American Champion Aircraft Corp.
Rochester, WI 53167

Service Letter: 422 Revision "A" (Page 1 of 4)

Title: Aluminum Gear Retrofit

Models: Bellanca/American Champion 7ECA, 7GCAA, 7GCBC, 7KCAB, 8KCAB, 8GCBC

Figure 1, 1-9998-1 Fairing Tube Installation

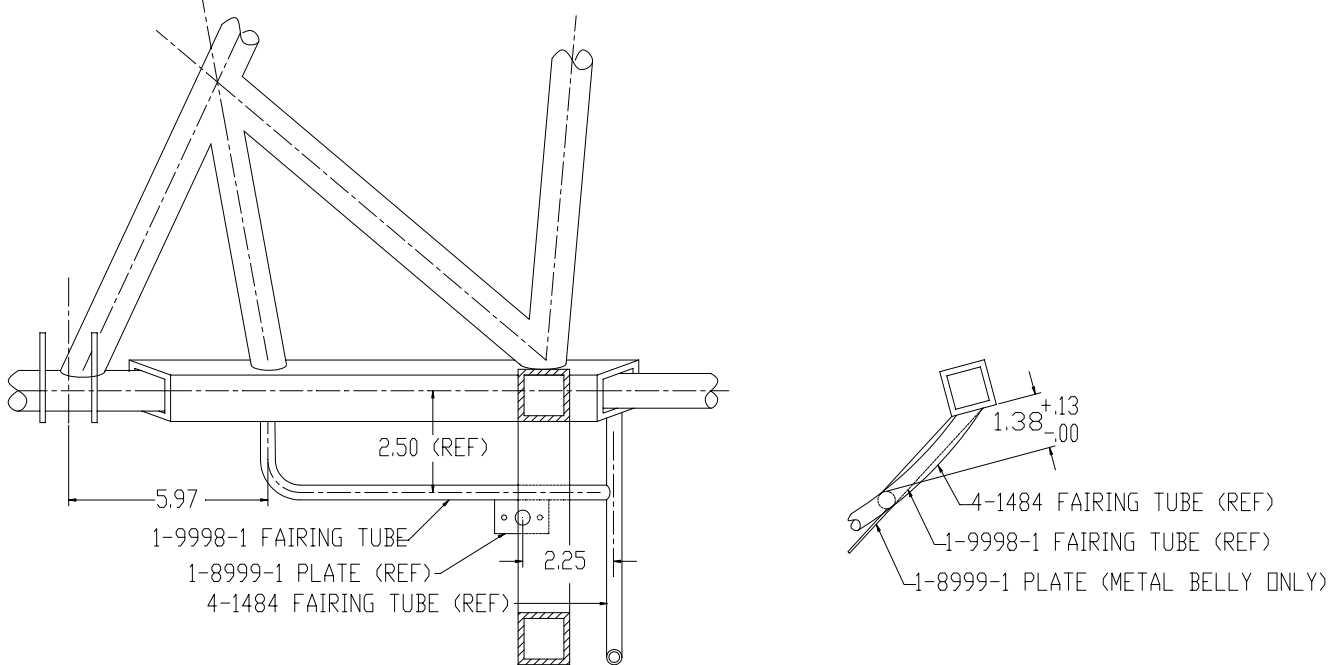
1. Refer to Service Manual for jacking of aircraft and procedure for removal of the old main landing gear leg assembly.
2. Remove fabric to expose 1-9998 fairing tube.
3. Remove 1-9998 tube, cut and grind flush to fuselage frame and 4-1484 fairing tube.
4. Grind 1-9998-1 tube to mate with fuselage frame.
5. Install 1-9998-1 tube per figure 1, weld per Champion Specification CW-1 or other industry accepted process for tubular steel welding.

6. If metal belly installed, install 1-8999-1 plate per figure 1, weld per CW-1 or other industry accepted process for tubular steel welding.
7. Treat all bare surfaces with zinc-chromate primer or equivalent.
8. Patch fabric and repaint in accordance with applicable ACAC service manual.

Figure 2, 3-1498 Skin Cutout

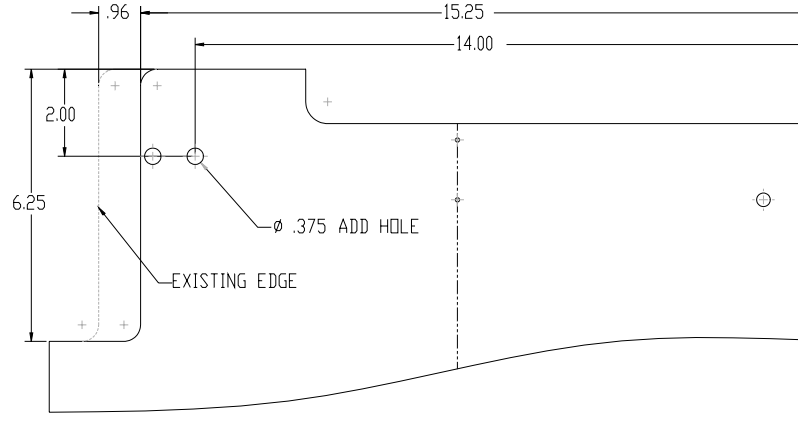
9. If metal belly installed, modify 3-1498 skin per figure 2.

Figure 3, 2-2111-9 Brake Line Installation

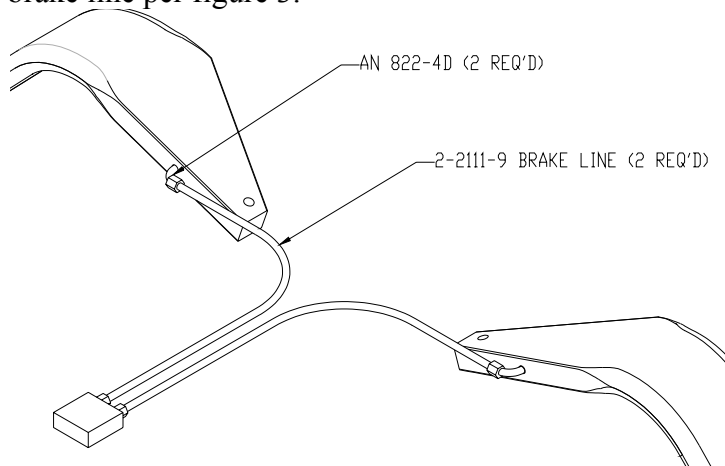
- 10. Install aluminum gear legs per ACAC drawing 7-1559 (no rev. or later) for all models except 8GCBC, for 8GCBC install per ACAC drawing 7-1579 (no rev. or later).
- 11. Remove 2-2111-8 (7-Series and 8KCAB) or 2-2133-2 (8GCBC) brake line and hardware and install 9563K84 snap plug in boot cowl.
- 12. Install 2-2111-9 brake line per figure 3.

Figure 4, Wheel Pant Cutout

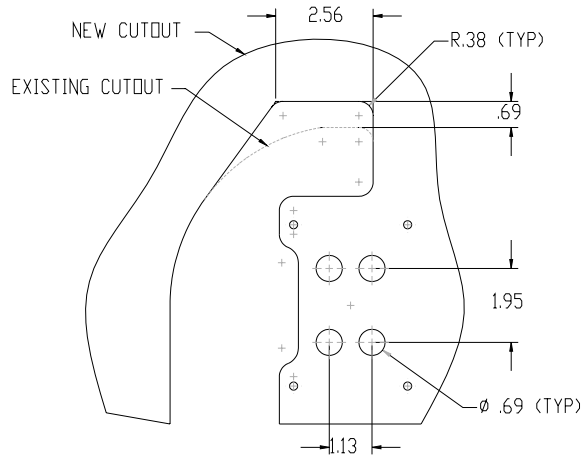
13. Modify wheel pant (Part Number 7-1541 L/R) per figure 4.
